Amendments:

Approved: 27/01/26
Date Issued: 27/01/26

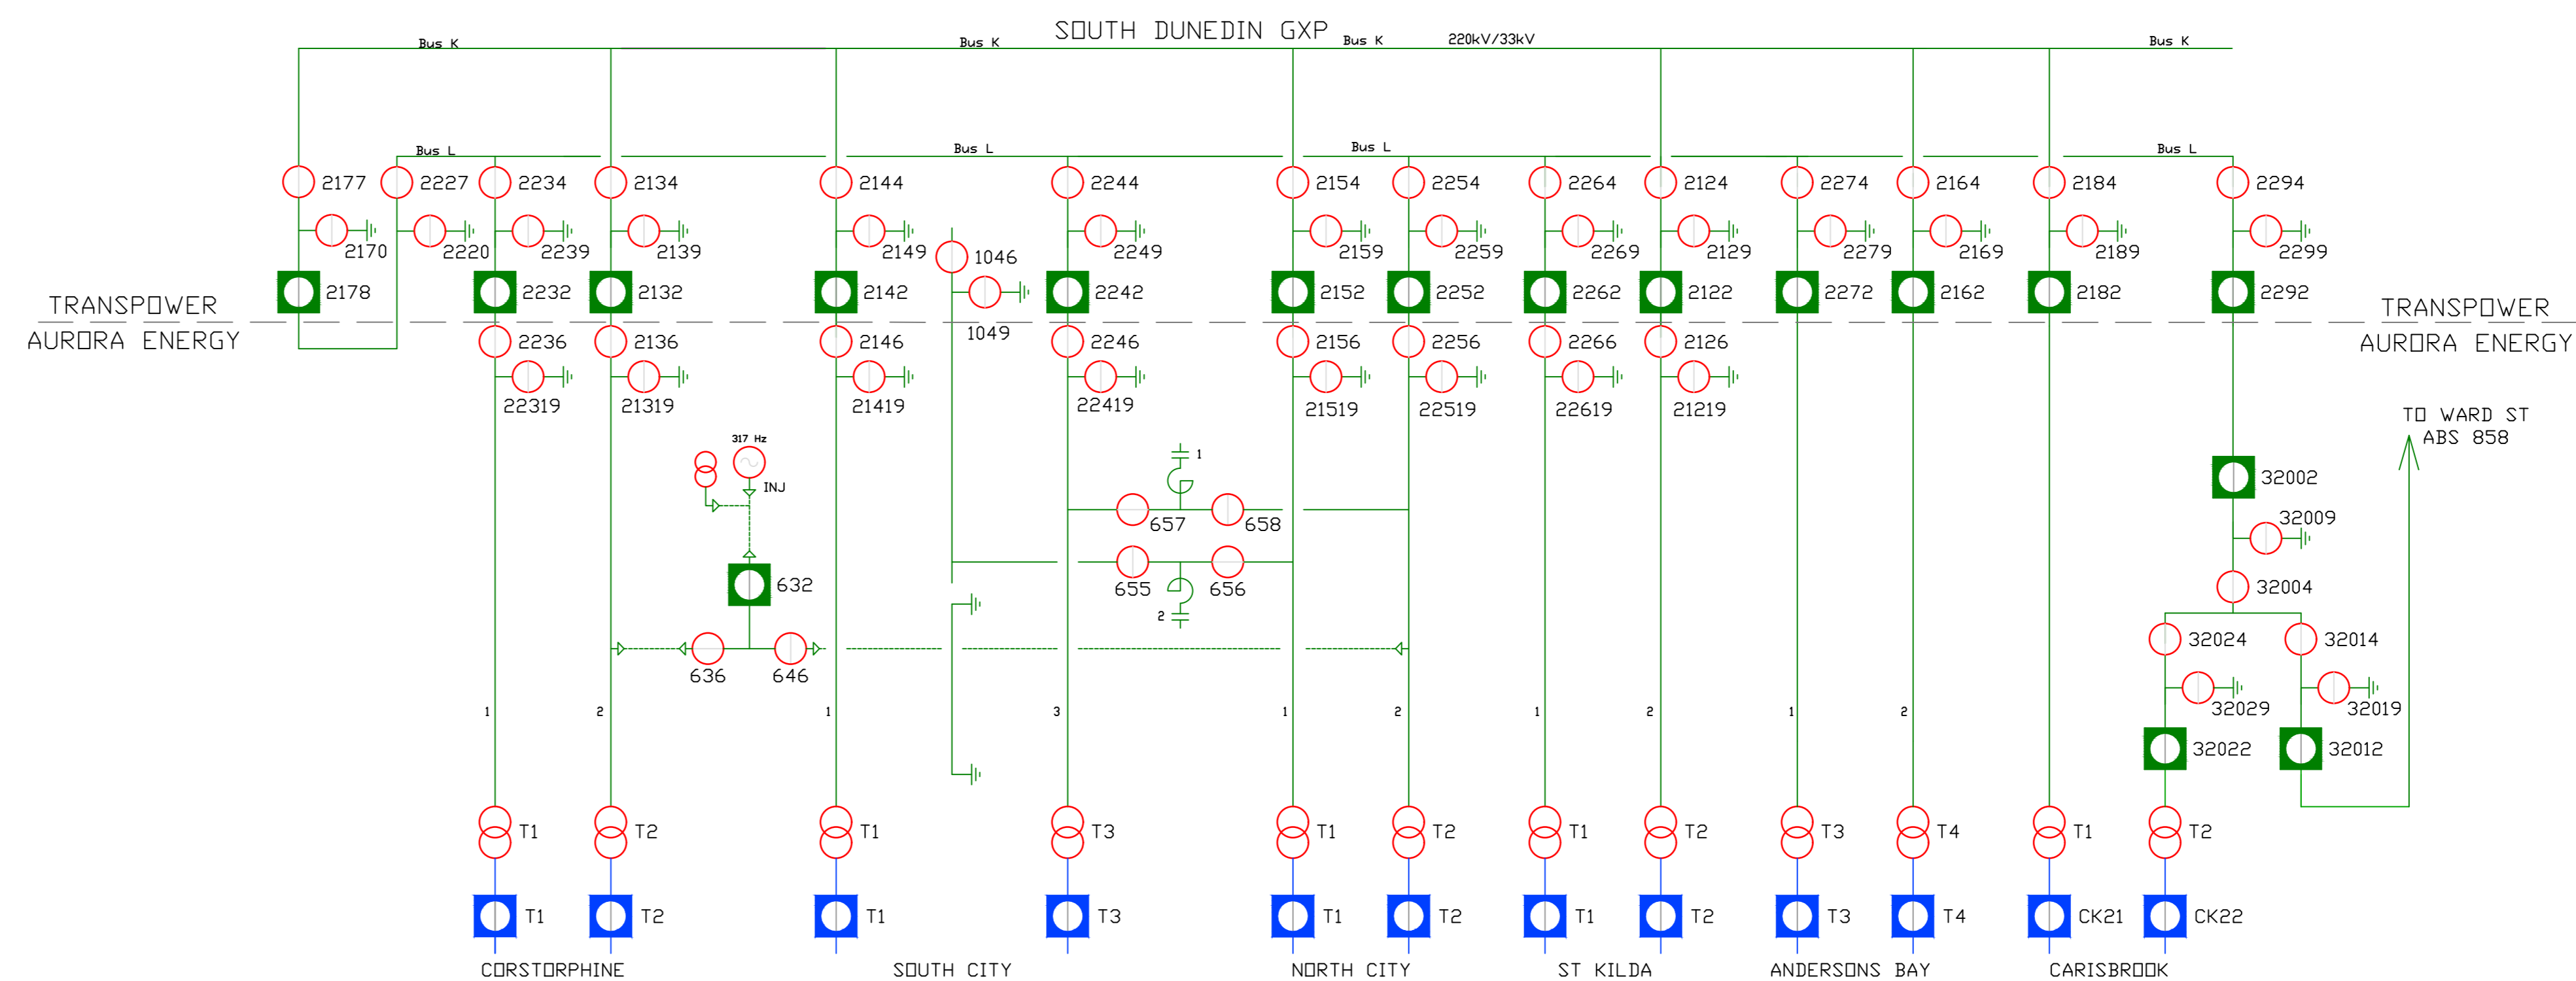
- 27-02-08 Berwick Switchgear changed
- 27-08-08 Berwick Switchgear changed, earth added to CB 2649
- 06-08-13 Added Isolator Switches & Earths AB&C Lines Berwick

- 10-02-15 Conversion stage 5.6 South Dunedin GXP GIS install
- 10-01-19 Links E326 in line with E322 at Berwick sub
- 02-5-19 Carisbrook project
- 13-08-20 Incorrect placeholder Isolator switches removed. AB T1 Isolators for Anderson's Bay removed and Carisbrook CB 32012 set to closed

- 15-10-20 AB T2 Isolators for Anderson's Bay removed
- 13-11-20 MAJOR OVERHAUL of HWB Take-off area regarding Transpower's assets
- 30-04-21 E304 replaced with E440

- 16-09-21 OUTRAM T3 replaces T1 & Mobile sub connection point
- 7-10-21 VTs added and South City T2 Mobile sub removed from plan
- 29-10-21 31152, 31154, 31156 added at Outram

- 17-01-22 Berwick Zone Sub Mobile sub connection point Links E330
- 02-06-22 E610 now connected to WB33-1 and not to GI33-1
- 03-06-22 Transpower VT removed from diagram

- 22-06-22 Links E330 removed. Links 324 is the correct Mobile Sub connection point
- 18-08-22 Transpower Isolator Switch corrected to 2644
- 11-05-23 Links E330 re-installed in Berwick Zone Sub

- 20-07-23 Remove E620, E622, E624 and E626 at Green Island Zone Sub
- 10-05-24 Andersons Bay T1 & T2 changed to T3 & T4
- 27-11-25 Switch 32014 is actually closed

- 23-12-25 Green Island CB T3 changed to GI221 & CB T4 changed to GI222
